SUBJECT: COUNTY REVIEW GROUP COMMENTS

PROJECT NAME: Offutt Ridge (Formerly Randall's Ridge)

RE: Item No. 168, Case No. 90-309-SPHA
Petitioner: Lavinia E. Craven, et al
Application for Zoning Variance and
Special Hearing

2ND ELECTION DISTRICT - BALTIMORE COUNTY - MARYLAND
PLAT FOR ZONING VARIANCES FOR LOT 75
PLAT 1 OFFUTT RIDGE

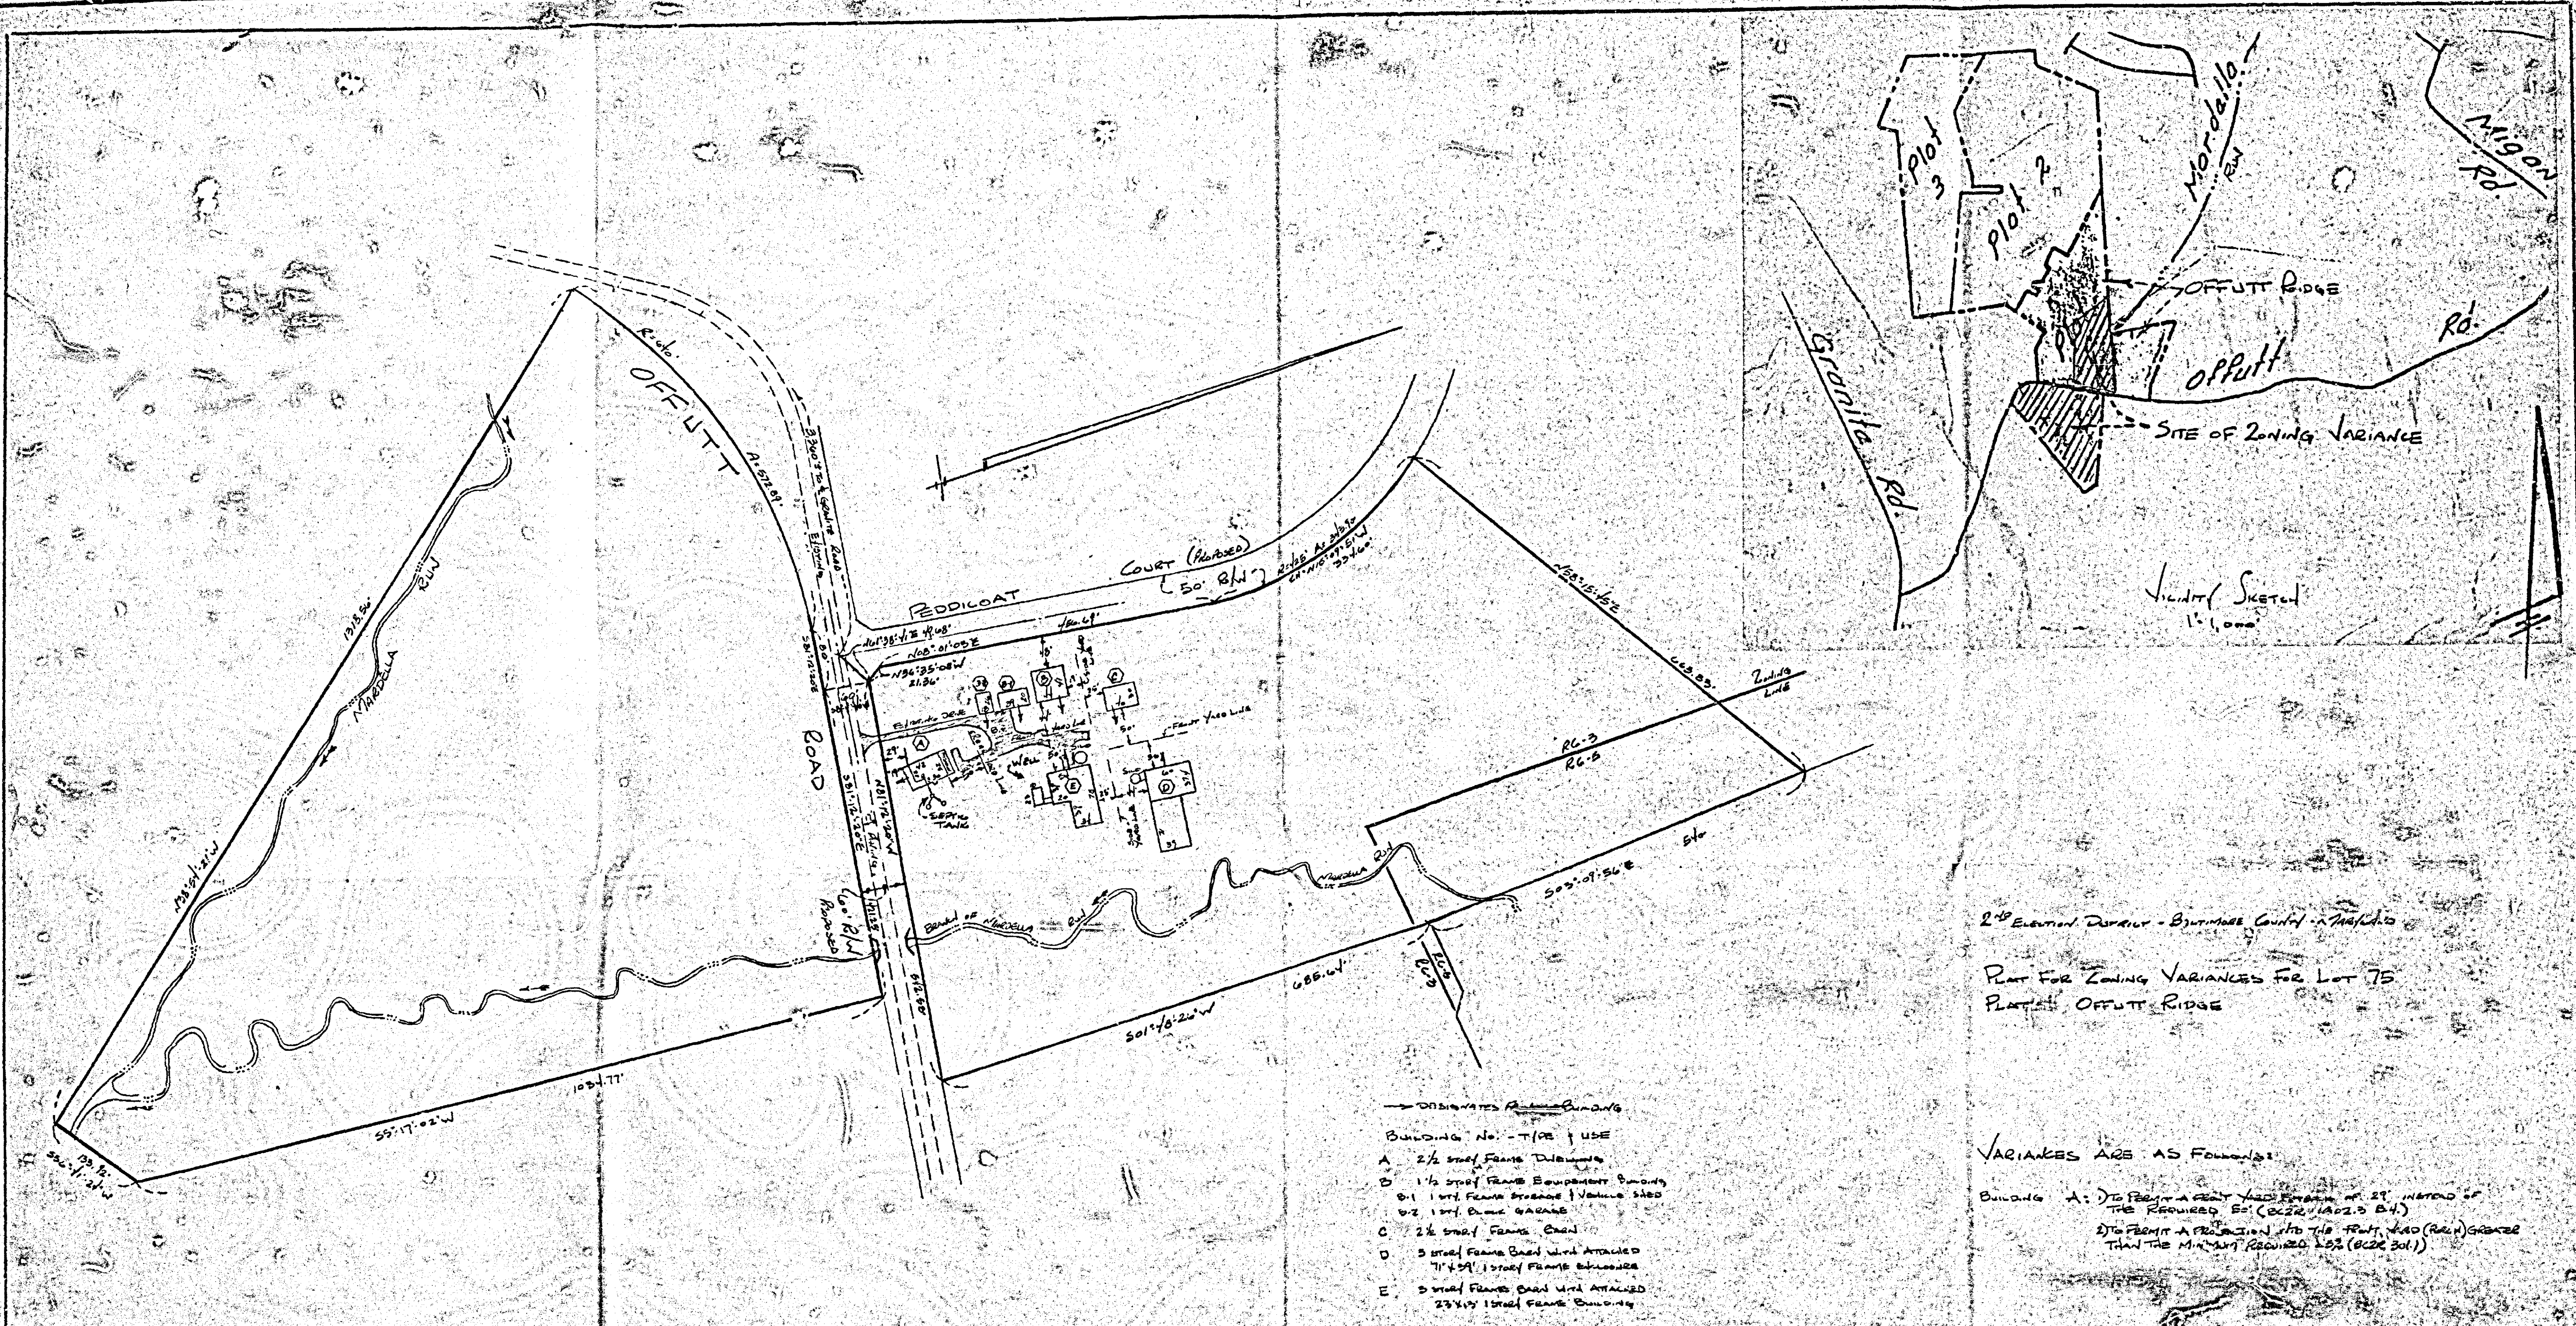
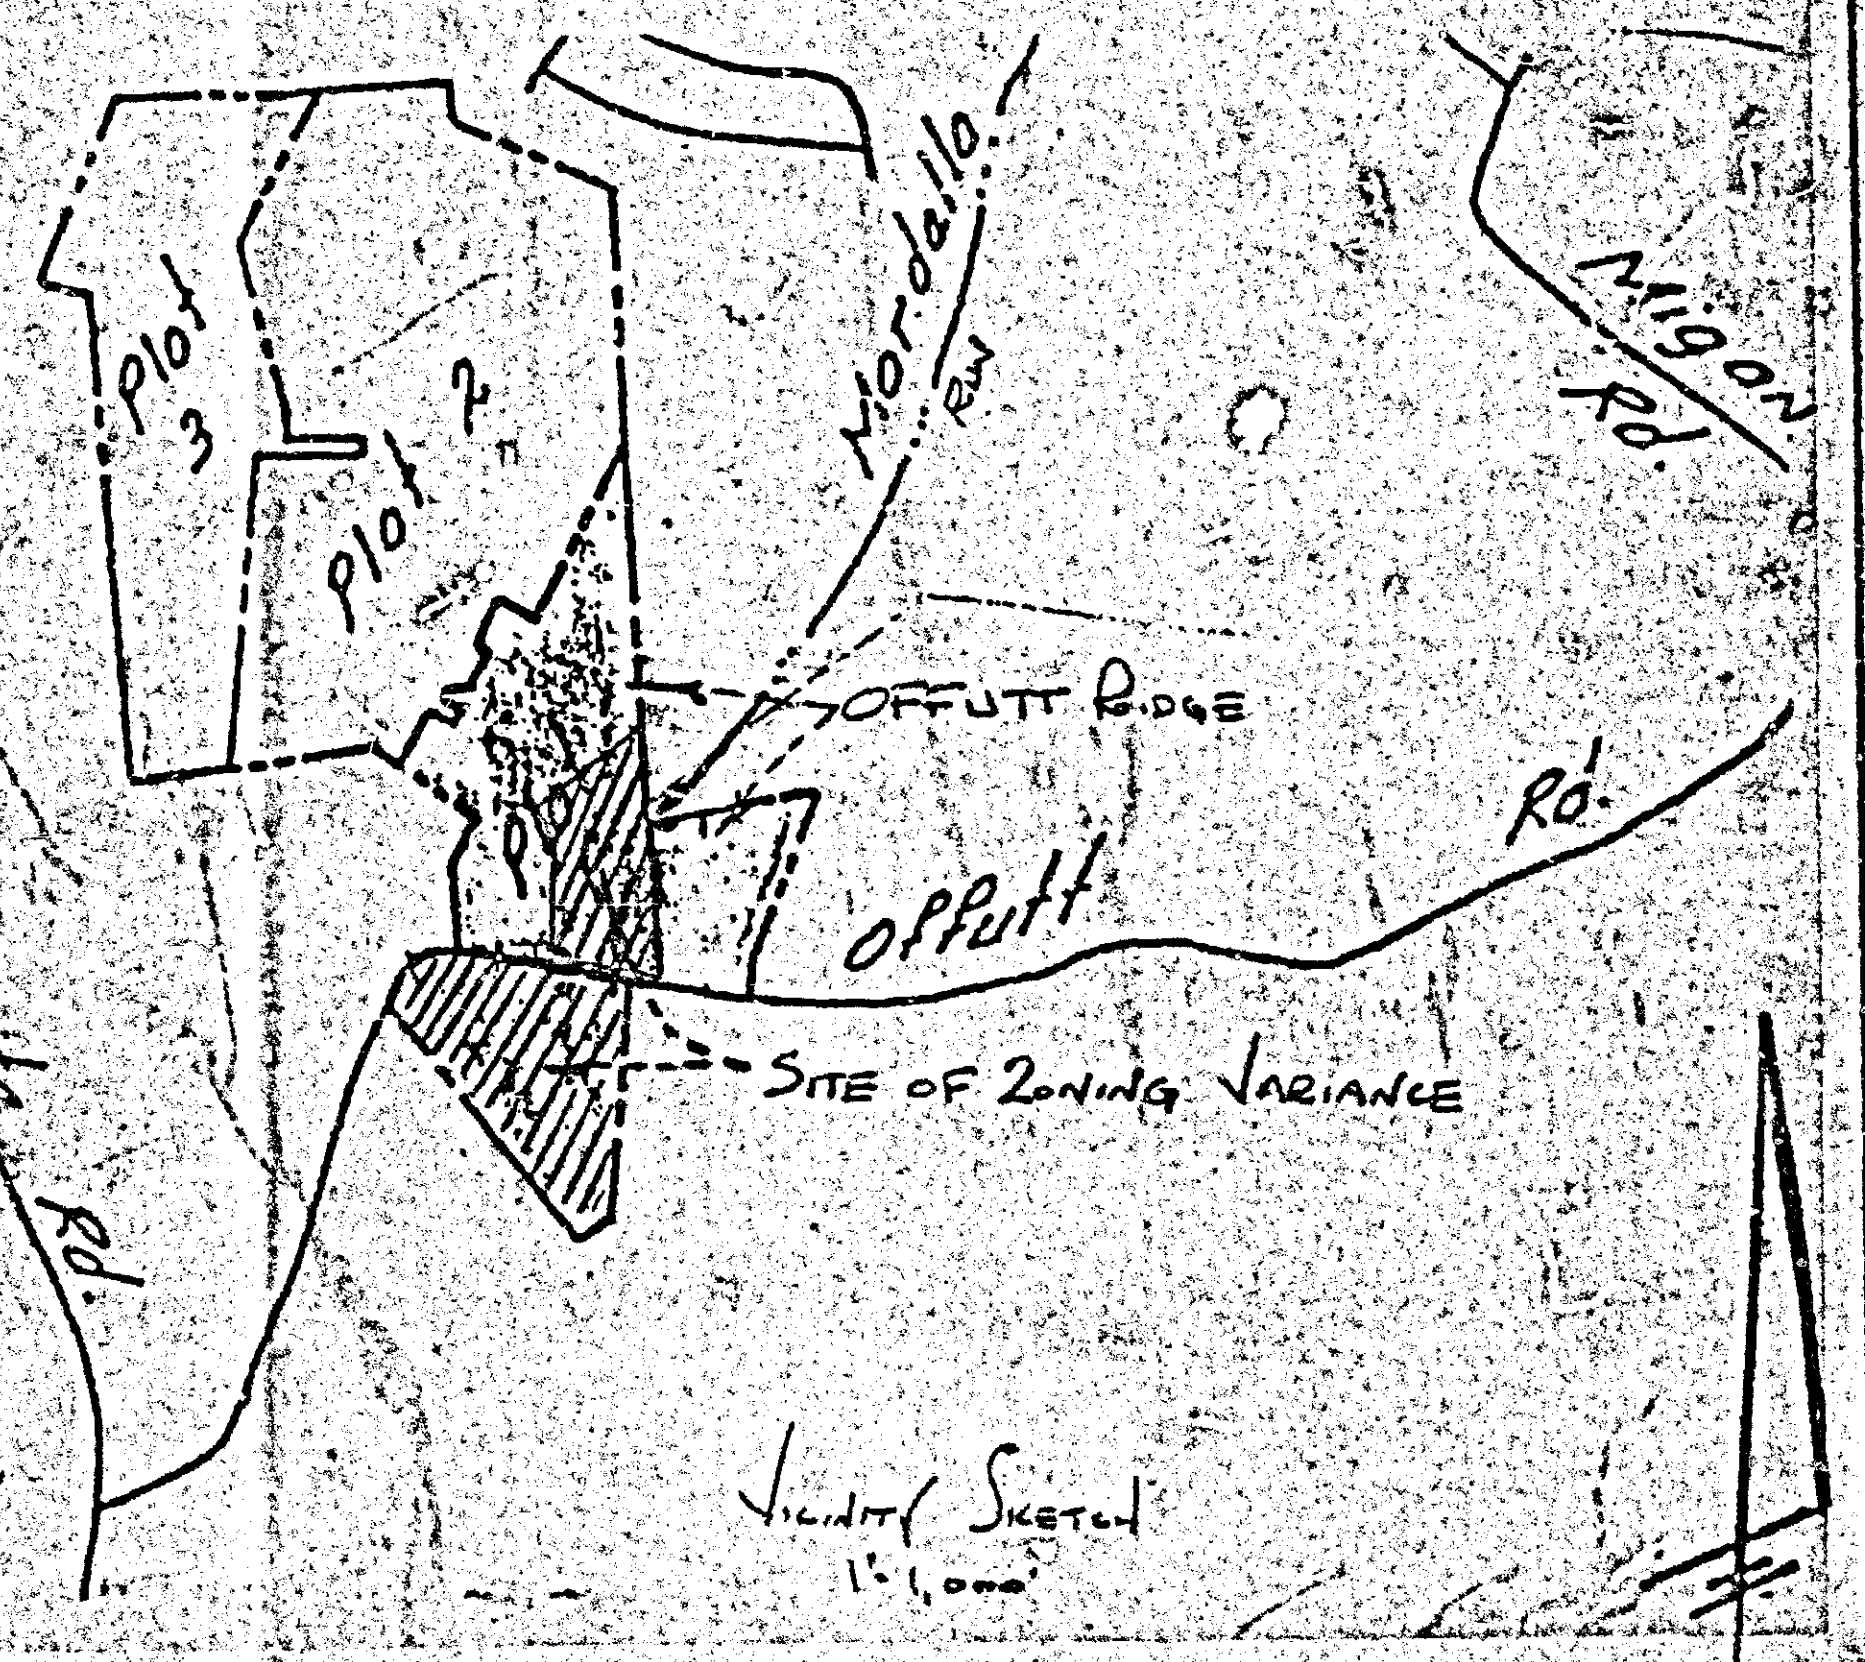
BUILDING A: 1) TO PERMIT A FRONT YARD SETBACK OF 23' INSTEAD OF THE REQUIRED 50' (BC2R 1A02.3 B.4)
2) TO PERMIT A PROJECTION INTO THE FRONT YARD (PCH) GREATER THAN THE MINIMUM REQUIRED 25% (BC2R 301.1)
